**REPORT TO GEORGES RIVER COUNCIL
IHAP MEETING OF 25 AUGUST 2016**

IHAP Report No	3	Development Application No	DA2015/0443
Site Address & Ward Locality	977 Forest Road Lugarno Peakhurst Ward		
Proposal	Fit out and use of ground floor of existing church building to be used as a child care centre for 34 children, associated landscaping and car parking works		
Report Author/s	Development Assessment Officer, Mr P Nelson		
Zoning:	Zone R2 - Low Density Residential		
Date of Lodgement	14 December 2015		
Owner	The Congregational Christian Church of Samoa Parish of Sydney Incorporated		
Applicant	Congregational Christian Church In Samoa Parish of Sydney		
Submissions	Forty five (45) submissions received		
Cost of Works	\$50,000.00		
Issues	Submissions received and variations to DCP1		
Recommendation	THAT the application be refused for the reasons included in the report

Site Plan

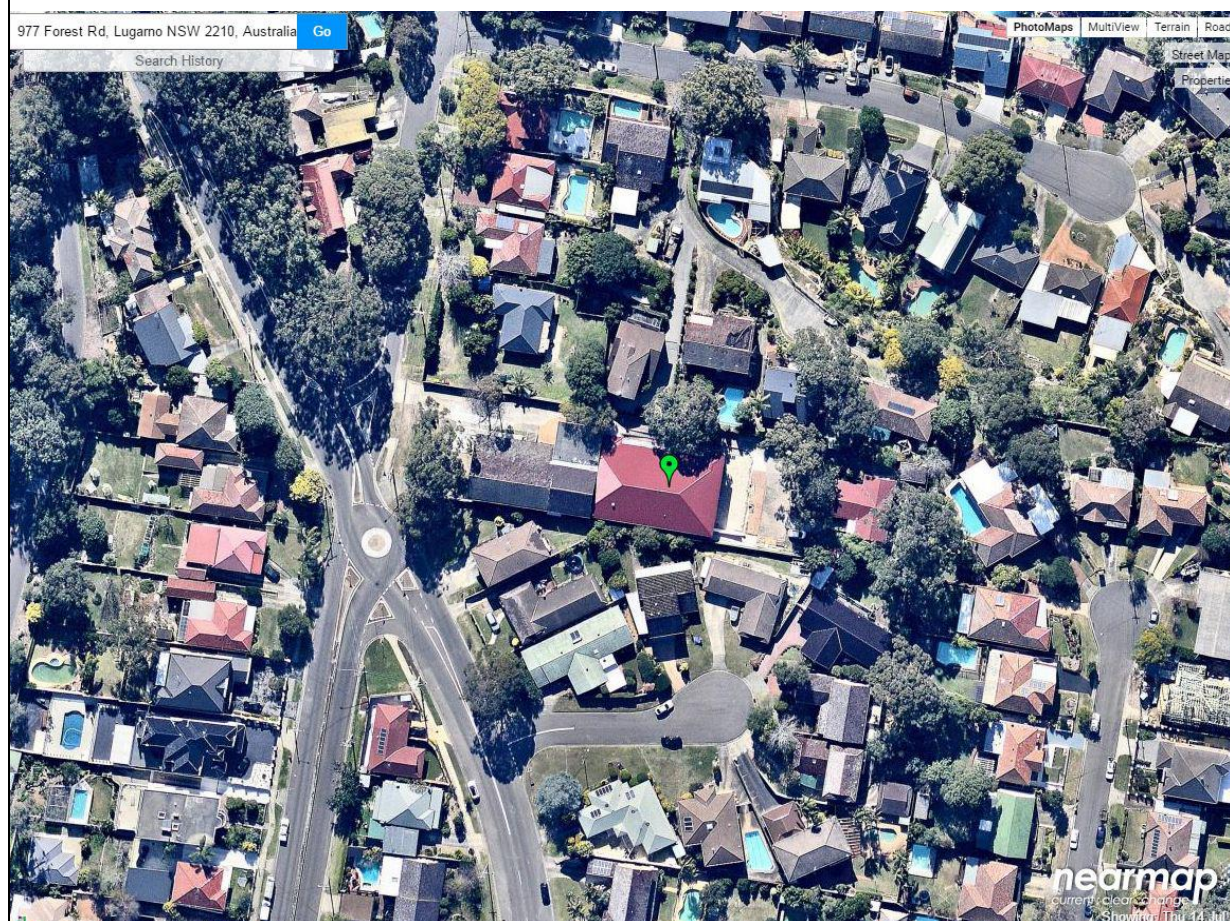
EXECUTIVE SUMMARY

1. Development consent is sought for the fit out and use of the existing ground floor/sub-floor area underneath the existing church hall as a child care centre for thirty four (34) children.

2. The application results in variations to both the Hurstville Local Environmental Plan 2012 and Development Control Plan No 1 - LGA Wide which warrant refusal of the proposal.

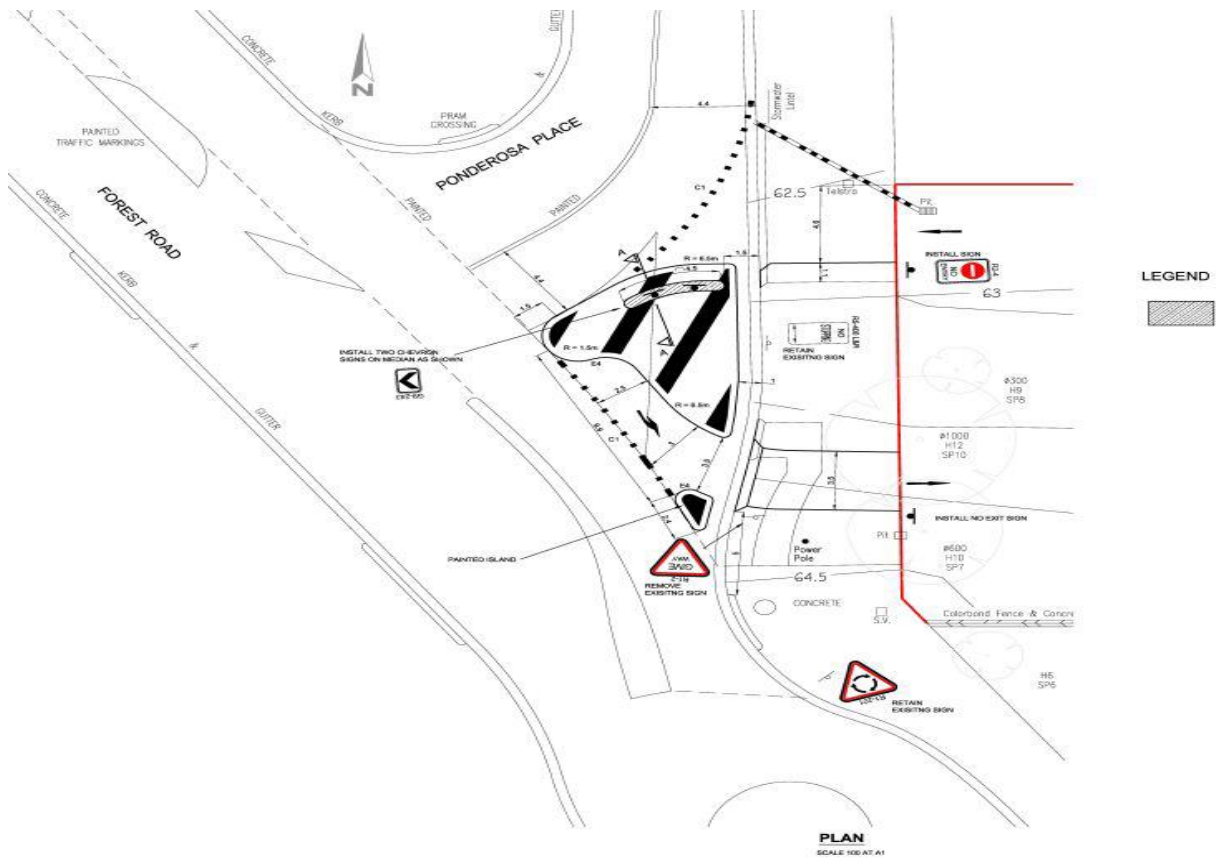
Provision of the proposed car parking spaces within the front setback of the existing Church building will require the removal of three (3) canopy providing trees including a Grey Gum (*Eucalyptus punctata*), a Blackbutt (*Eucalyptus pilularis*) and a Willow Gum (*Eucalyptus scoparia*).

Provision of additional car parking at the rear of the site will require the removal of one (1) significant Willow Gum (*Eucalyptus scoparia*) and the removal of an exempt Silky Oak (*Grevillea robusta*).

Vehicular access to the site is to be amended to provide an additional driveway on the southern side of the site providing a drive through arrangement at the front of the site. This will enable vehicles to enter and exit the site in a forward direction.

9. The tree removal is proposed in order to provide for dual driveway access to the site and to provide for seven (7) car parking spaces between the front boundary and the front building alignment.

The removal of the significant trees on site is not supported and as such the dual driveway and associated parking spaces at the front of the site cannot be achieved.

In addition to this the vehicular access to the rear car parking area is problematic for the use of the child care centre in terms of pedestrian safety. The driveway is of insufficient width to allow for the provision of pedestrian access and vehicular access. This impact is compounded by the need for the single driveway (2.8m side) to provide both pedestrian and two-way vehicular access to the child care centre and parking at the rear of the site.
